**NUMBER:** 08-055-05

Satellite Radio Intermittent Static

This bulletin involves replacing the Satellite Digital Audio Receiver (SDAR).

**Fig. 1 REVISED SDAR MOUNTING HOLE LOCATIONS**

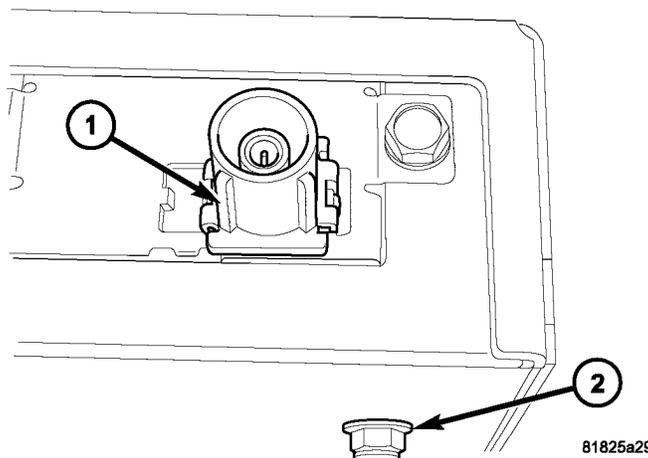
2. CS, KJ, LH , PT, RS, WK and XK vehicles go to step 4. DR, HB, JR and ND go step 3. LX vehicles require the SDAR mounting bracket to be modified as follows:
  - a. Place a drop of paint or correction fluid (white out) on the top of each of the (3) SDAR mounting studs of the replacement SDAR.
  - b. Position the SDAR mounting studs against the SDAR mounting bracket so the wiring connectors of the SDAR are facing toward the front of the vehicle when the SDAR/bracket assembly is mounted in the vehicle and the mounting stud opposite the SDAR wiring connectors is 3/16 in. inboard of the crease in the SDAR mounting bracket, (Fig. 1)
  - c. Drill 5/16 in. (8mm) holes in the SDAR mounting bracket at the three locations marked by the paint.

- 1 - DRILL 5/16 IN. (8MM) HOLES AT THE LOCATIONS MARKED BY THE SDAR STUDS
- 2 - FRONT OF VEHICLE WHEN INSTALLED

**Fig. 2 TAN SDAR CONNECTOR**

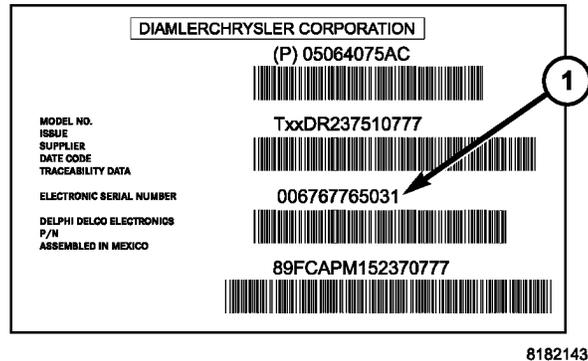
- 
3. For DR, HB, JR, LX and ND vehicles, remove the left locating key (when viewed with the SDAR mounting studs facing you) on the tan connector of the SDAR. The key can be shaved off using a utility knife or similar device, (Fig. 2). Continue with step 8.

- 1 - REMOVE THE LEFT LOCATING KEY
- 2 - SDAR MOUNTING STUD
